Access Compliance Report

Public Rights-of-Way

(Curb Ramps)

Intersection ID: 8228	Main Street: CROSSRIDGE_RD	Cross Street: SULLINS_RD	Location:	S
ADA ID: 15930554EC97	Ramp Type: Perp	Initial Pass/Fail: Fail	Overall Compliance: No	Severity Score: 10
Codes/Mitigation Info/Possible Solution		Field Measurements/Component Compliance

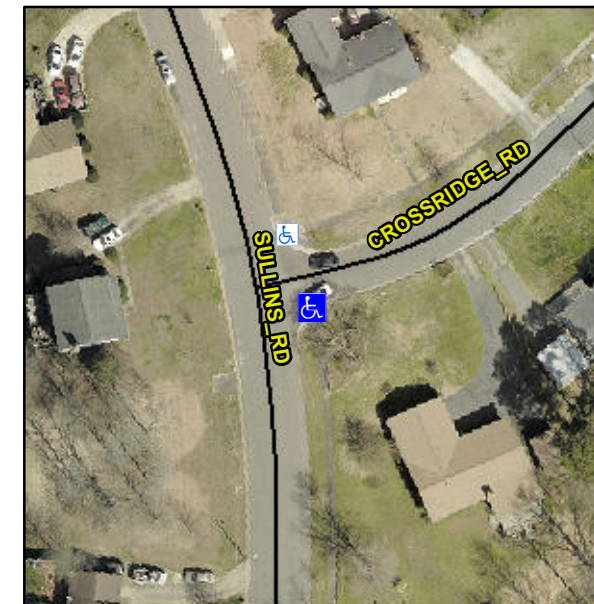
Not Found, R304.5.1, R304.5.3

Compliance	Description	Data	Compliance	Description	Data
N/A	Ramp Length (in)	58.0	Yes	Ramp Slope (%)	7.2
No	Ramp Width (in)	37.0	No	Ramp XSlope (%)	4.7
N/A	Flare Type LT	N/A	N/A	Flare Type RT	N/A
N/A	Flare Slope LT (%)	N/A	N/A	Flare Slope RT (%)	N/A
N/A	Flare Traversable LT?	N/A	N/A	Flare Traversable RT?	N/A
N/A	Landing Length (in)	N/A	N/A	DWS Provided?	N/A
N/A	Landing Width (in)	N/A	N/A	DWS Contrast?	N/A
N/A	Landing Slope (%)	N/A	N/A	DWS Length (in)	N/A
N/A	Landing X Slope (%)	N/A	N/A	DWS Full Width?	N/A
N/A	Landing Curb? (Y/N)	N/A	N/A	DWS Offset (in)	N/A
N/A	Shared Landing?	N/A			
N/A	Gutter Ponding?	N/A	N/A	Gutter Slope (%)	N/A
N/A	Gutter Lip Ht (in)	0.5	N/A	Gutter X Slope (%)	N/A
N/A	Painted X Walk1?	No	N/A	Painted X Walk2?	N/A
	X Walk 1 Direction	To N		X Walk 2 Direction	N/A
N/A	X Walk 1 Width (in)	N/A	N/A	X Walk 2 Width (in)	N/A
	X Walk 1 Slope (%)	3.7		X Walk 2 Slope (%)	N/A
	X Walk 1 X Slope (%)	1.3		X Walk 2 X Slope (%)	N/A

Remove & Replace Entire Ramp.
